Doc. No.: HUS-CEA-ED-LTR-00008

Subject: Response to Husky Energy Exploration Drilling Project – Round II Information Requirements.

**Husky Exploration Drilling Project:
Response to Round 2 Information
Requirements from Environmental
Impact Statement Review**

ED-HSE-RP-0040

Figure 1 Phase Speed (solid lines) and Group Speed (dashed lines) of Tsunami Waves on a Flat Earth Covered by Oceans of 100 m to 6 km depth (top). Wavelength Associated with Each Wave Period (bottom)

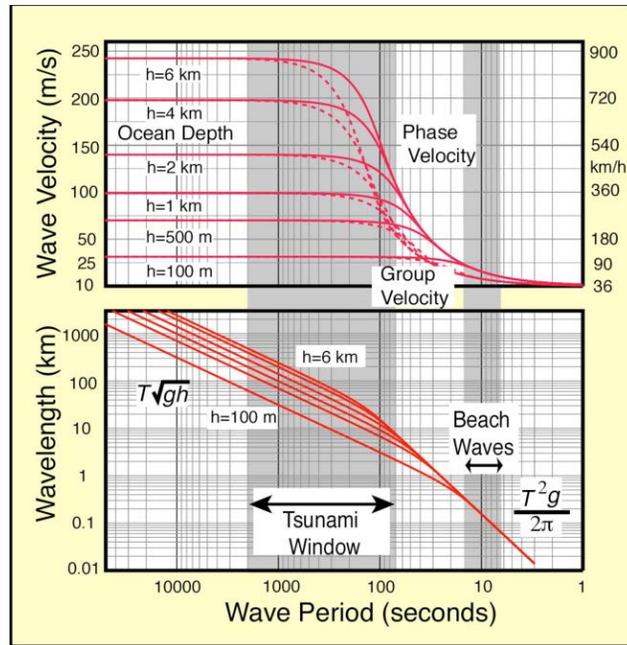
Discuss whether a tsunami wave would break on the relatively shallow waters of the Grand Banks and describe how much the wave could potentially grow in height and narrow in width.

Tsunamis can be created by a submarine earthquake, a landslide, or - extremely rarely - a meteor impact (Lynett and Liu 2011). Tsunami waves behave like shallow-water waves, as their wavelength is much larger than the ocean water depth. Typical tsunami waves have periods ranging from 70 s to even 2,000 s (Figure 1). The tsunami velocity can be approximated by the formula of the phase speed of shallow water waves

where g is the acceleration due to gravity (9.8 m/s^2) and H is the depth of water. Depending on the wave depth, tsunami waves can travel at 160 to 250 m/s (Figure 1). In the open ocean, tsunami waves have a wavelength of 10 to even 100 km (Figure 1). Tsunami wave height in the open ocean is imperceptible and smaller than 1 m.

Figure 1 Zone of Influences from Permanent Light Sources in the Project Area (assuming a 16 km radius from light source)

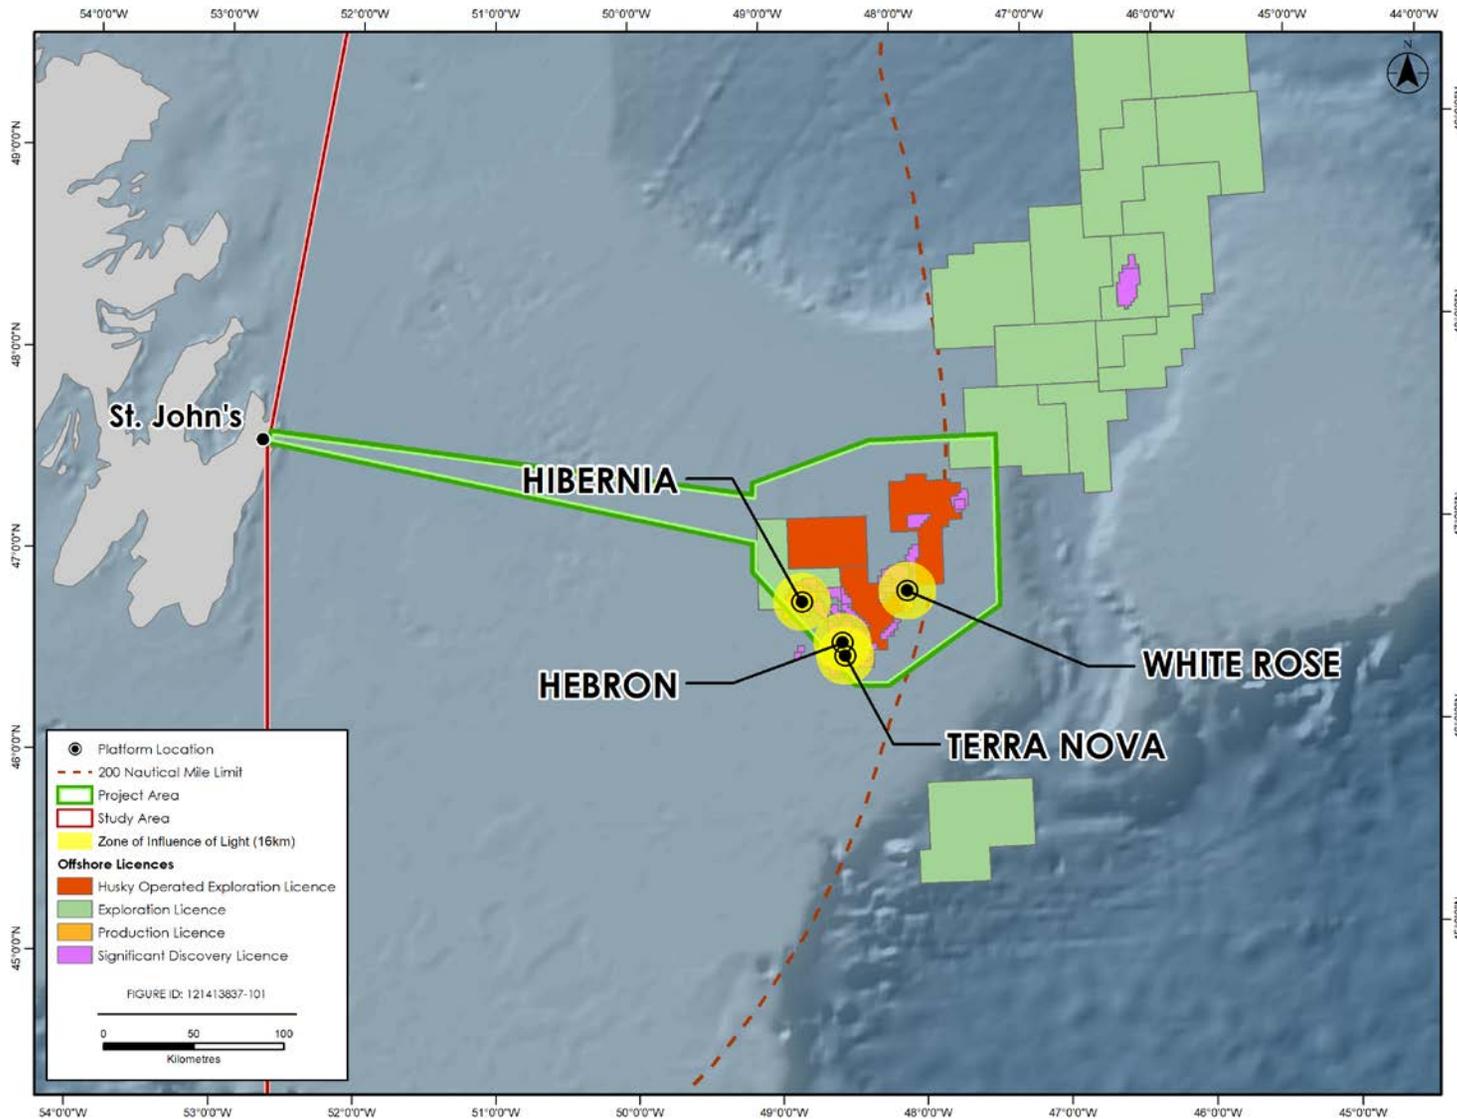
Provide information to support the statement related to the contribution of light from the Project to the area.

Provide information to support the statement that the distance between projects operating in the Newfoundland and Labrador offshore would allow birds to pass between projects without being influenced.

Figure 1 illustrates the zones of influence (ZOI) of light created by existing production platform locations within the Study Area, which include Hibernia, Hebron, Terra Nova and White Rose. It has been noted that lighting attraction effects are anticipated to be confined to within approximately 5 km (Poot et al. 2008) to 16 km (Rodríguez et al. 2014, 2015) of the source. For the purpose of Figure 1, the largest anticipated ZOI (16 km) was used.

The previous IR response indicated that birds could pass between projects without being influenced by the artificial light produced by offshore exploration activities. Based on Figure 1, this is currently true for some of the current platforms. A migrating bird could currently pass between White Rose and any other platform,

It is also important to note that oil and gas exploration and production activities are not the only sources of artificial light in the offshore environment; fishing fleets and cargo vessels are other mobile sources. These are not shown in Figure 1, as they could occur throughout the Project Area at any time.
